ONE SYDNEY HARBOUR

BARANGAROO SOUTH

STAGE 1B - Building R4B

SECTION 4.55

LEVEL	RL
Podium P1	8.400

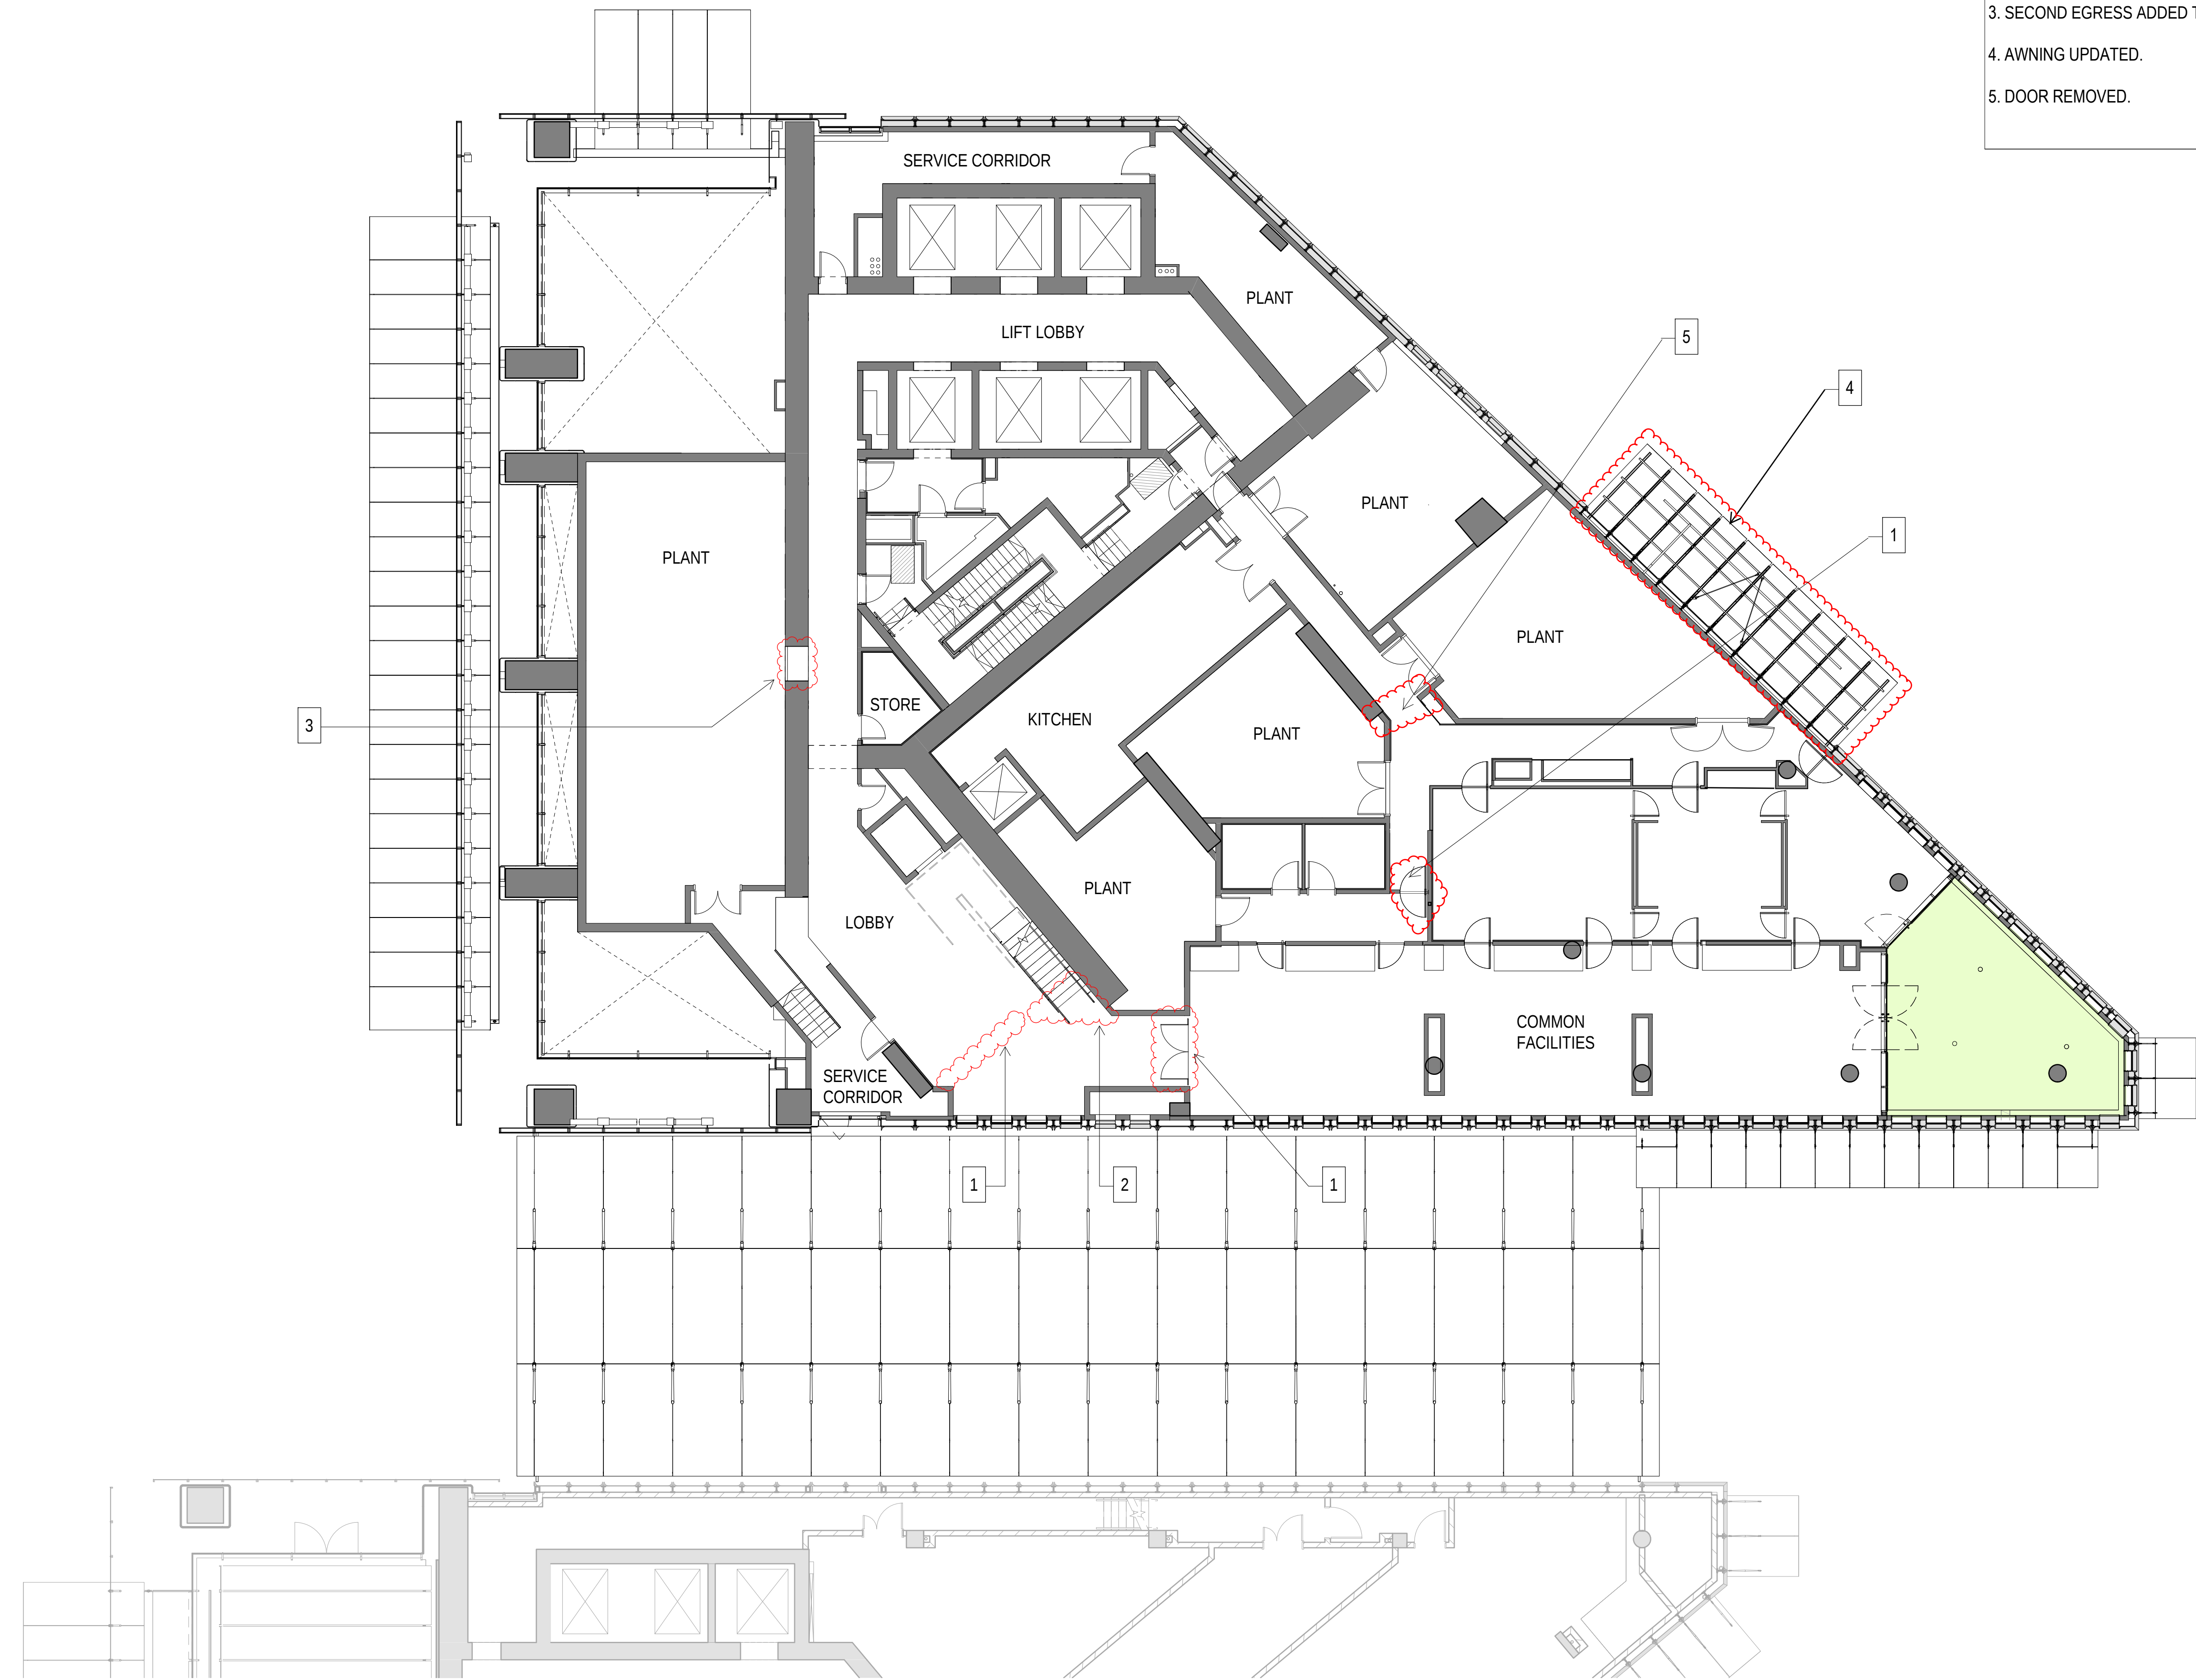
- MODIFICATION:**
- 1. DOOR ADJUSTED.
 - 2. AMENITY STAIR ADJUSTED, STORE ROOM REMOVED.
 - 3. SECOND EGRESS ADDED TO MEZZANINE PLANT.
 - 4. AWNING UPDATED.
 - 5. DOOR REMOVED.

LEVEL	RL
Podium P2	12.900

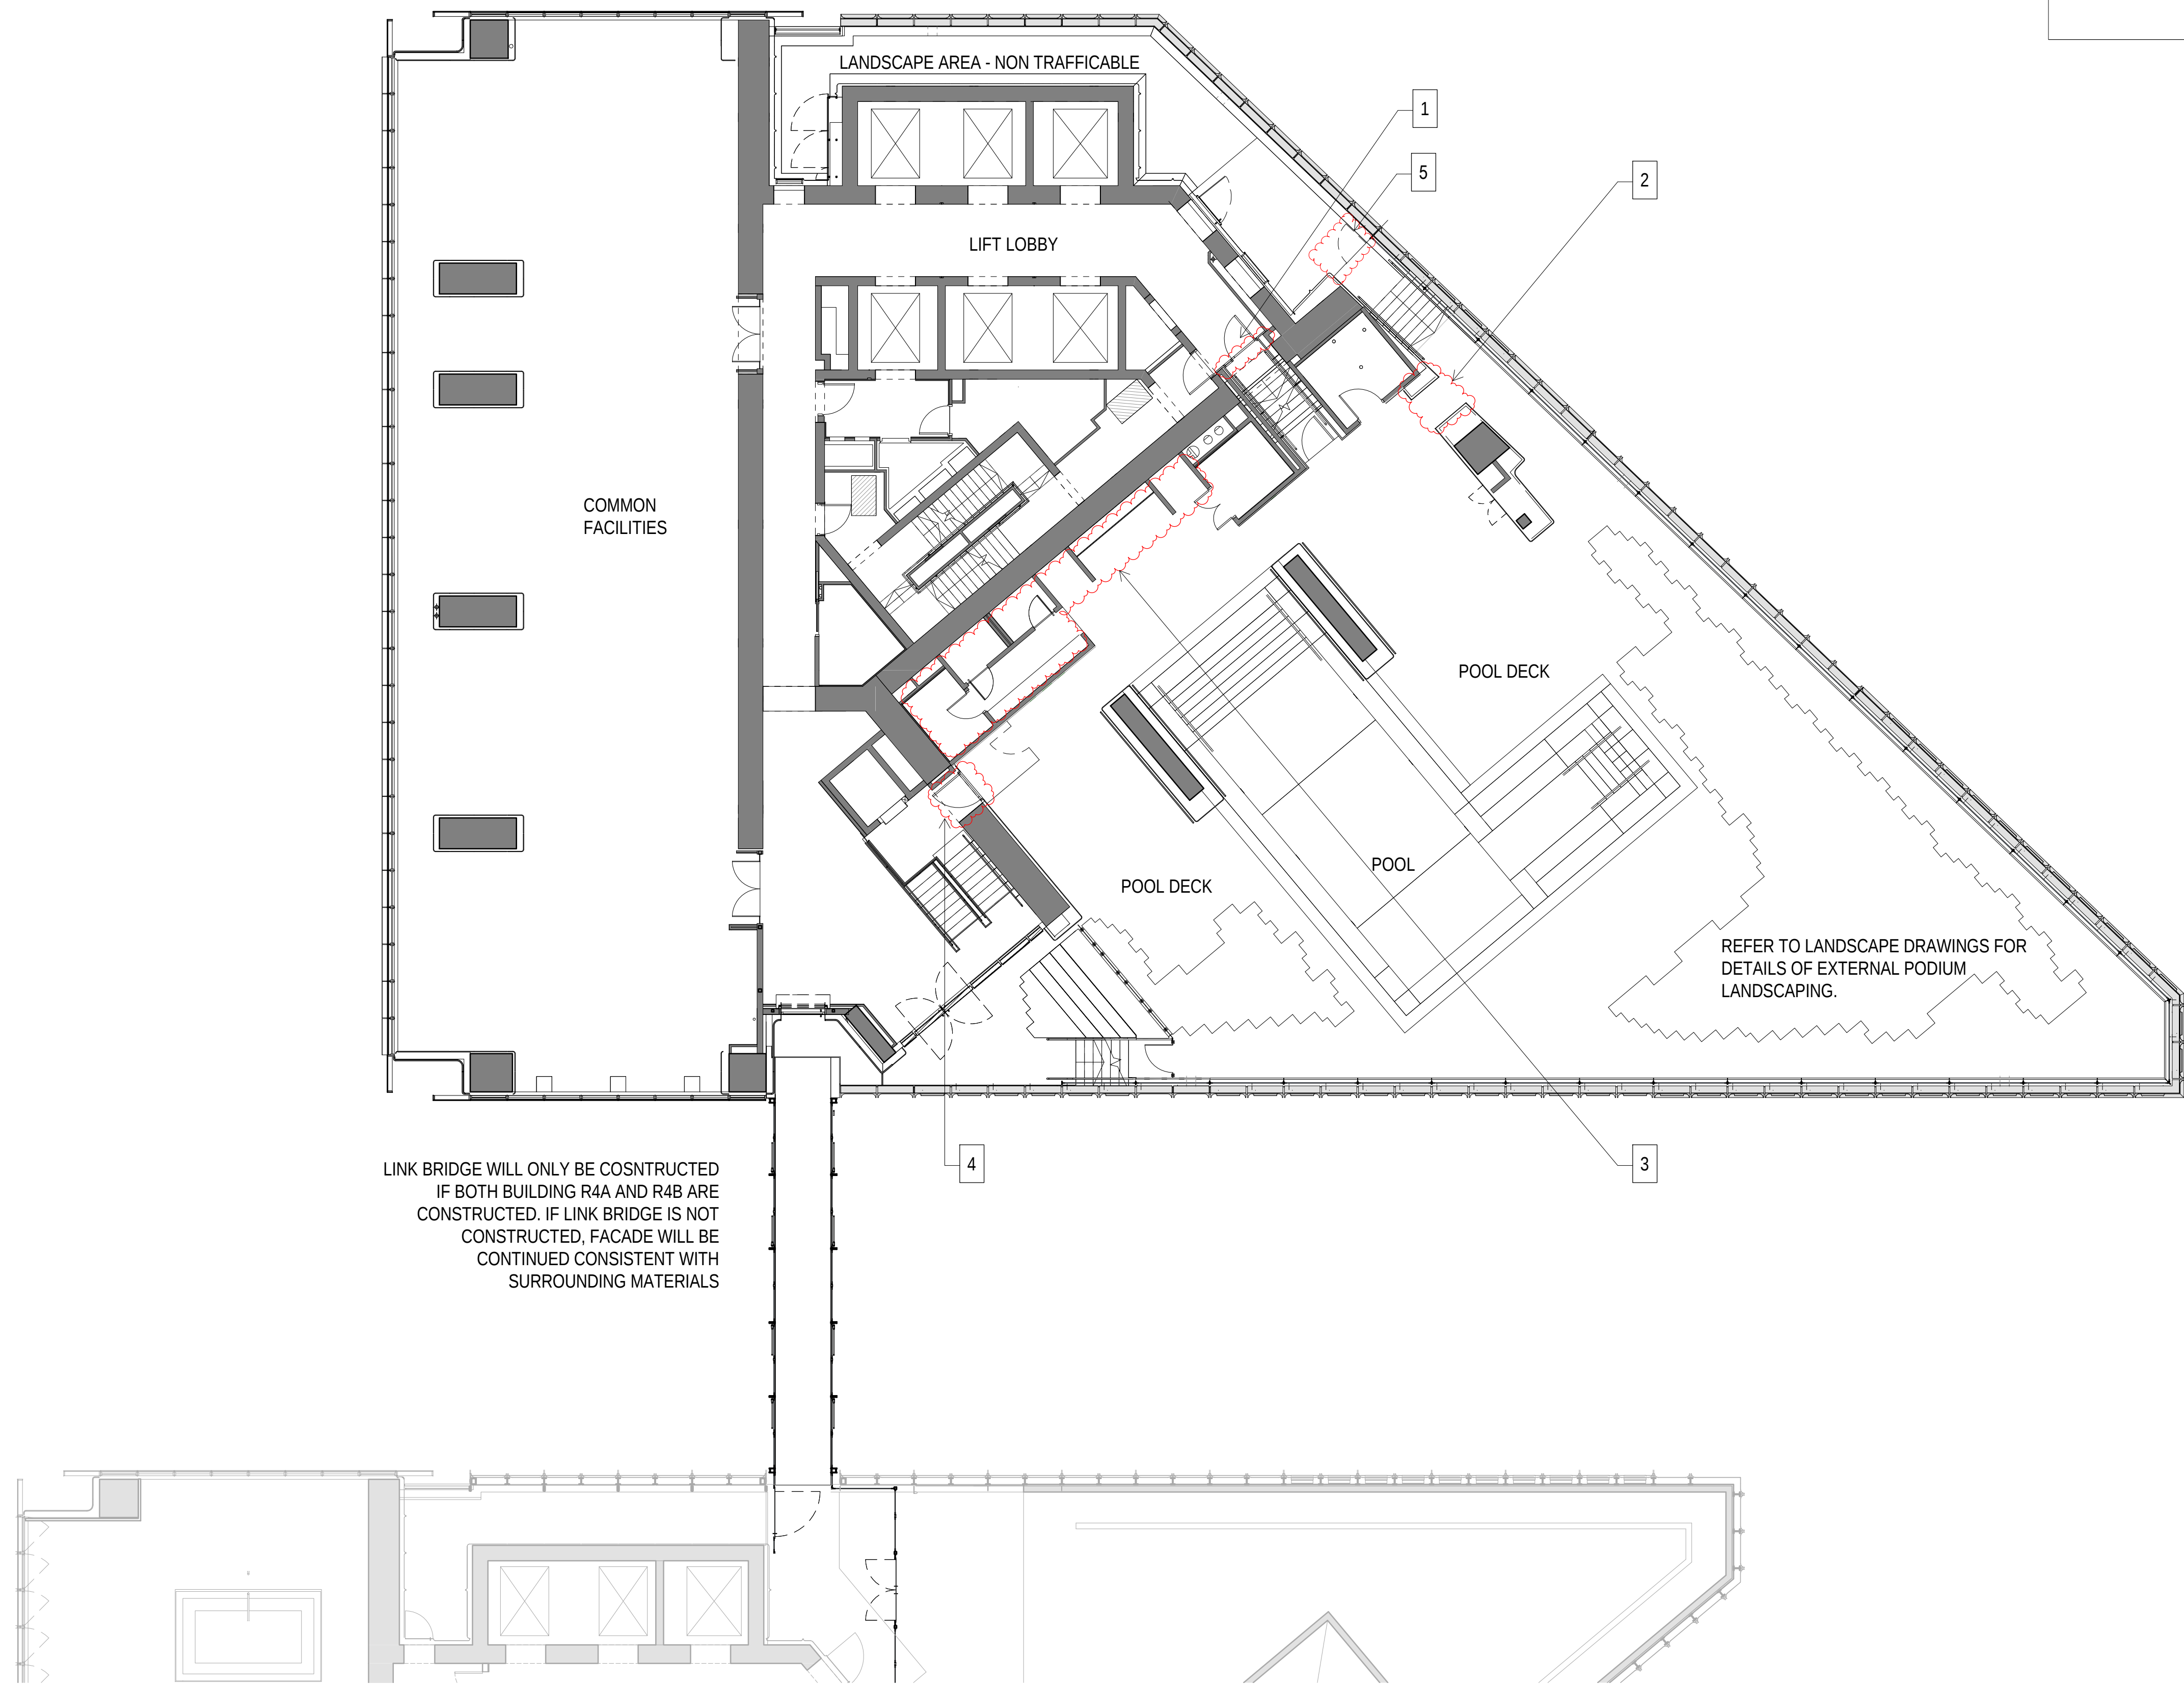
- MODIFICATION:**
1. SLIDING DOOR CHANGED TO SWING DOOR.
 2. FACADE UPDATED.
 3. SHOWER AREA AND AMENITY CHANGED.
 4. DOUBLE DOOR CHANGED TO SINGLE DOOR.
 5. DOUBLE GATE CHANGED TO SINGLE GATE.

LEVEL	RL
R4B L20	77.595

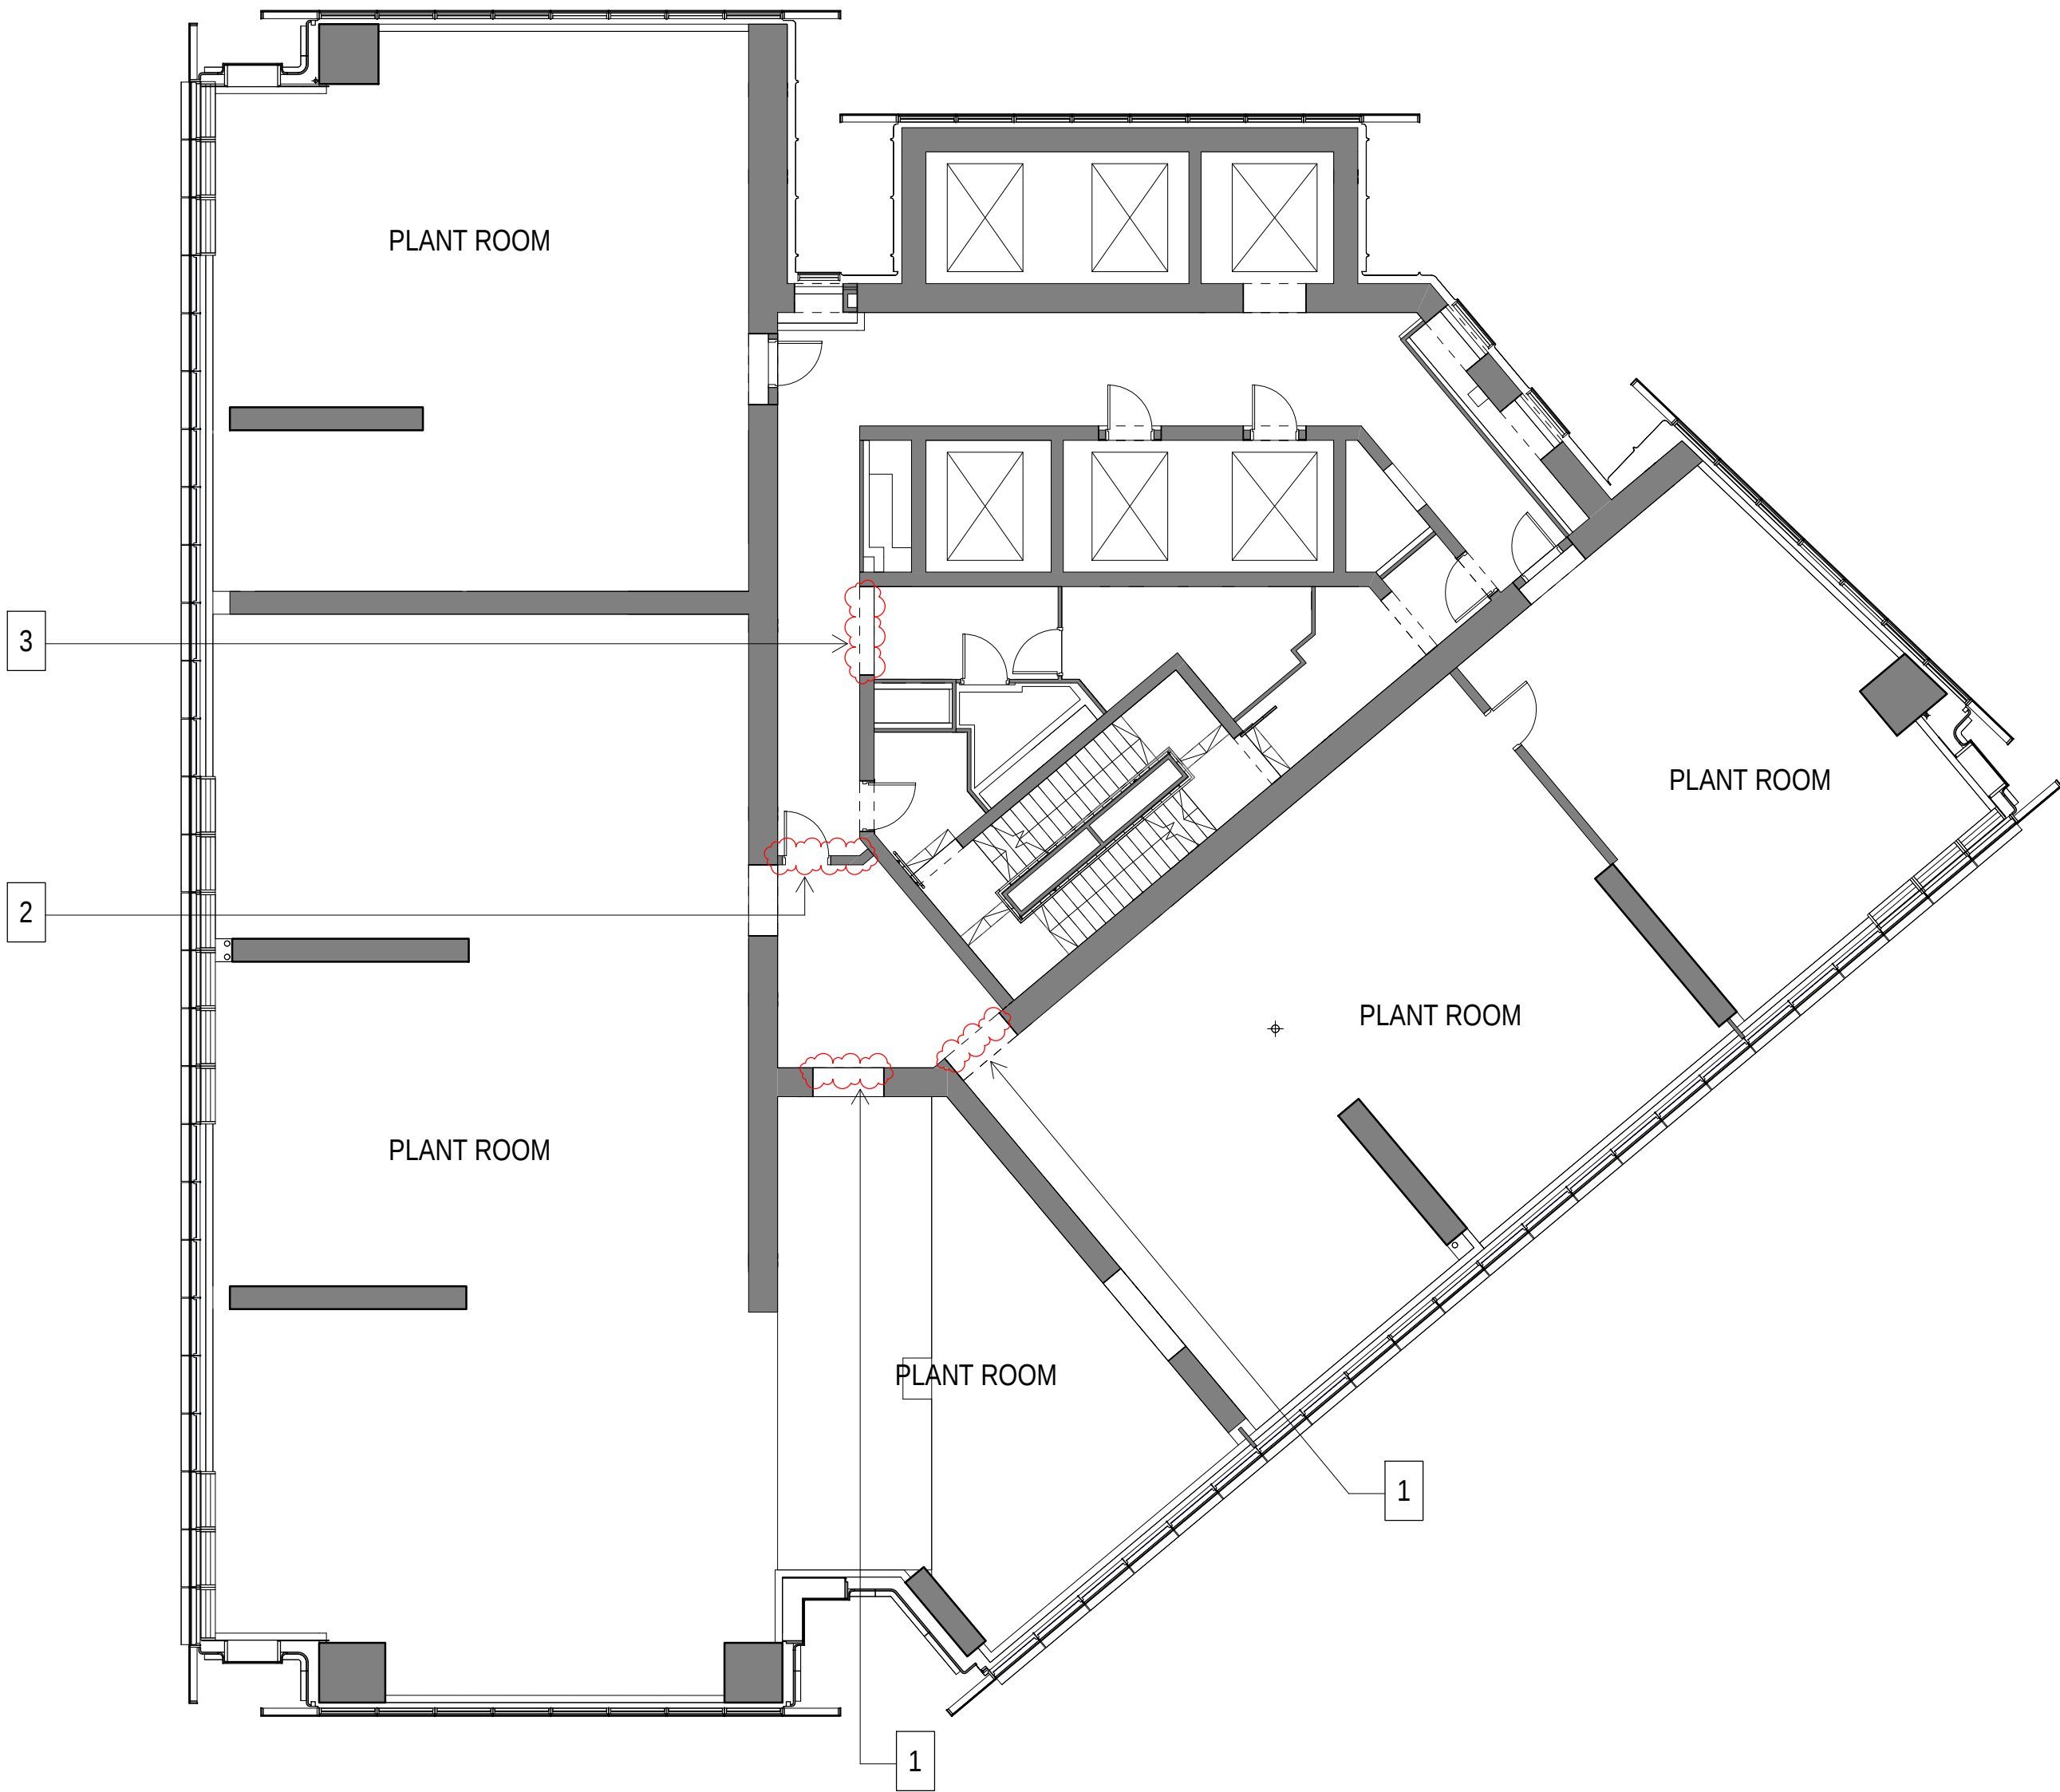
1. DOORS REMOVED.

2. WALL & DOOR ADDED.

3. WALL & DOOR REMOVED.
